## DESIGN REVIEW BOARD RECOMMENDATION MEETING

2ND + STEWART | 1613 2ND AVENUE

DPD# 3016702 September 29, 2015

garage exit to the south | future streetcar

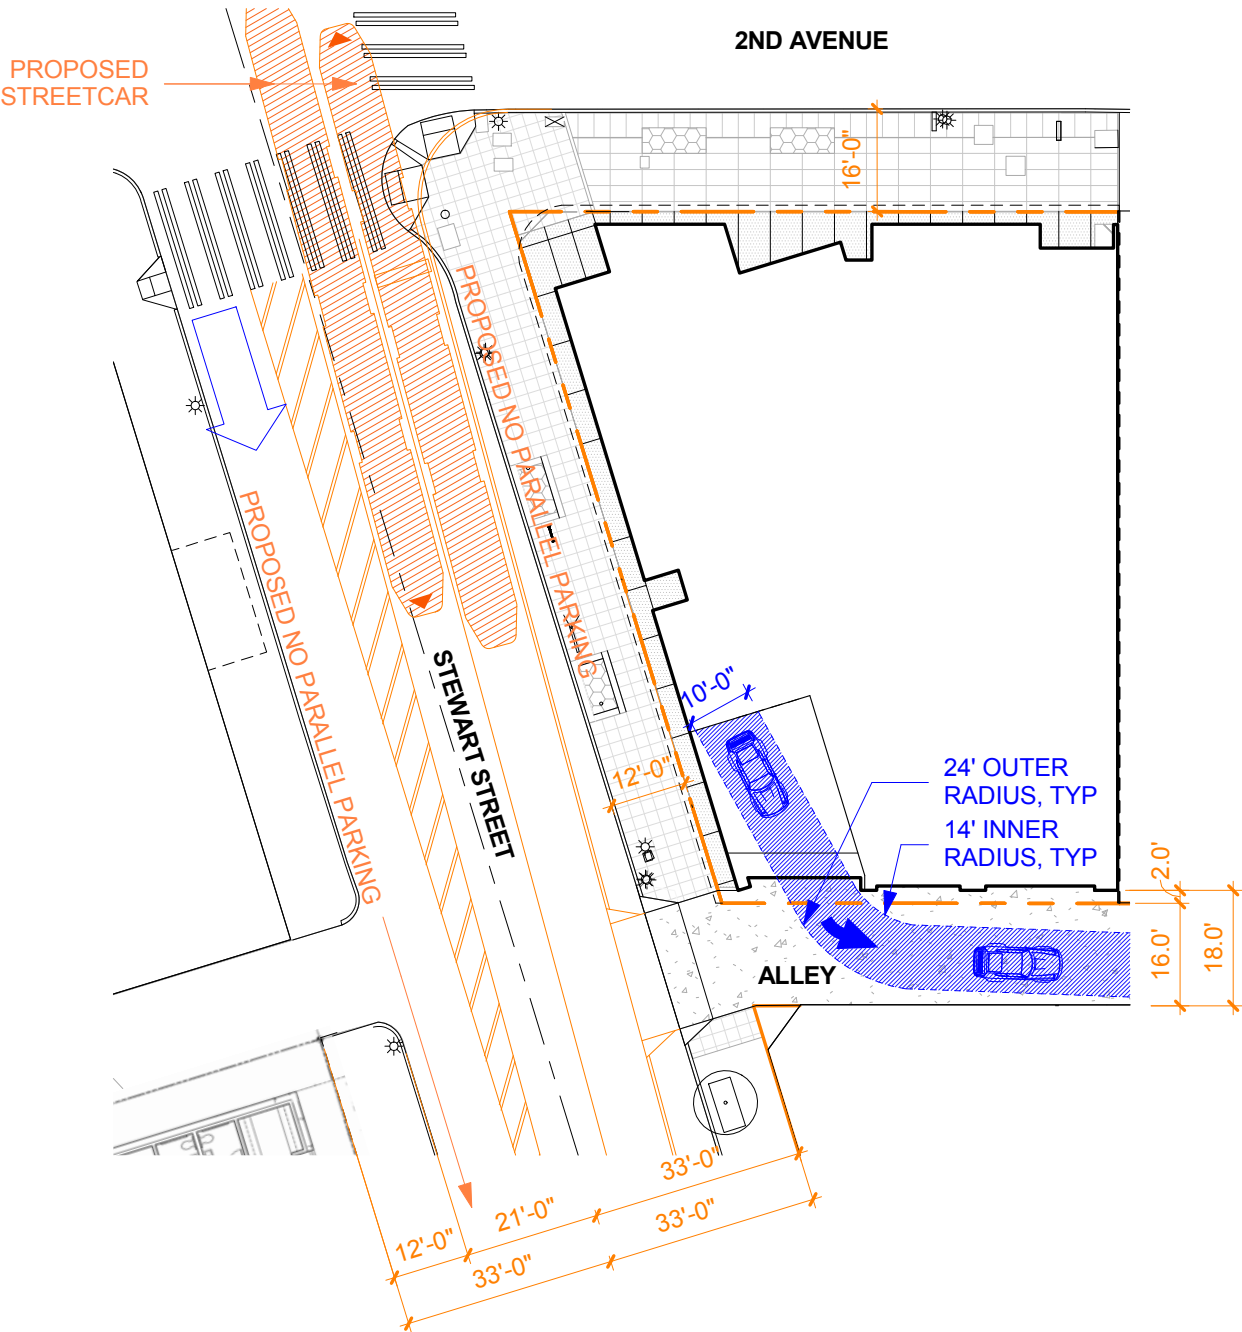
**Board's Deliberations:**  
"Demonstrate to the Board how the turning radii in and out of the parking openings would work safely and effectively."

**Response:**  
Please see turning radius diagram on the following pages for entry and exit into the northern garage in both "no street car" and "future street car" configurations.

street level view from hotel on Stewart Street

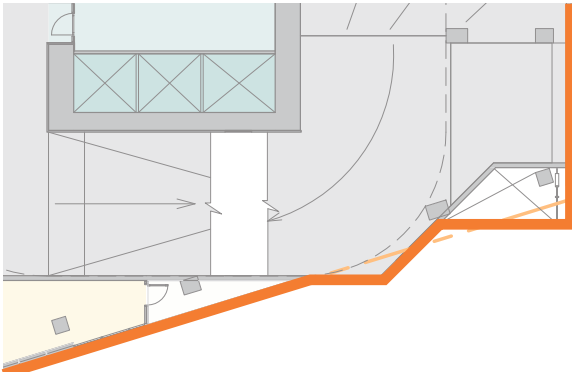
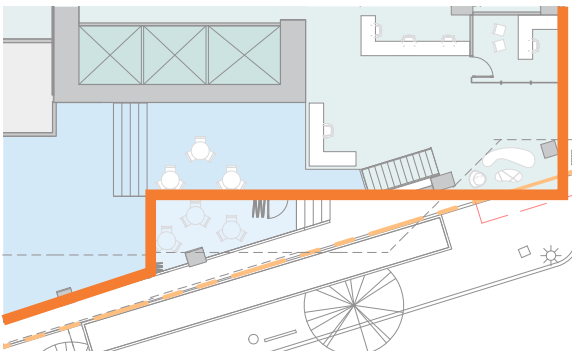
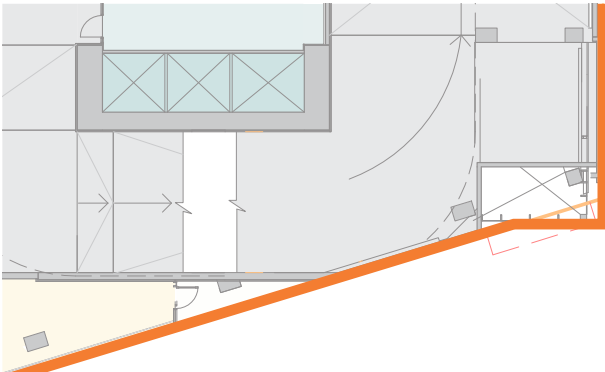
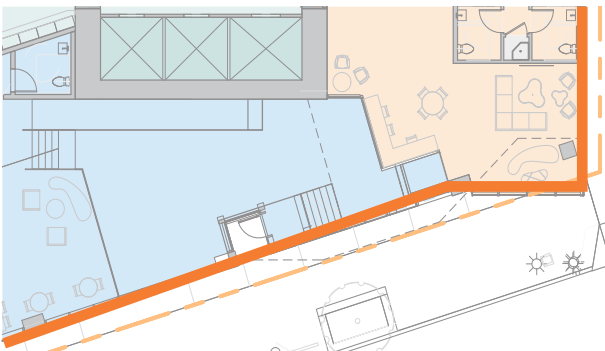
**Board's Deliberations:**  
Moving the leasing space up to a mezzanine level was acknowledged as a good move by the Board, but they also thought that the external expression of this and related spaces at the northwest lower corner, the junction of the alley and Stewart Street, as portrayed in both alternative one and two, needed to be revisited. It was suggested that the creation of a dynamic corner was a good idea, but perhaps the present rendering exhibited too many acute angles. As expressed by one of the Board members, the treatment of the lower corner should be as elegant as the treatment of the rest of the building.

**Response:**  
Since the EDG #2 meeting the massing at the corner has been simplified. A structural building overhang relating to the above grade parking level ramps has been removed.
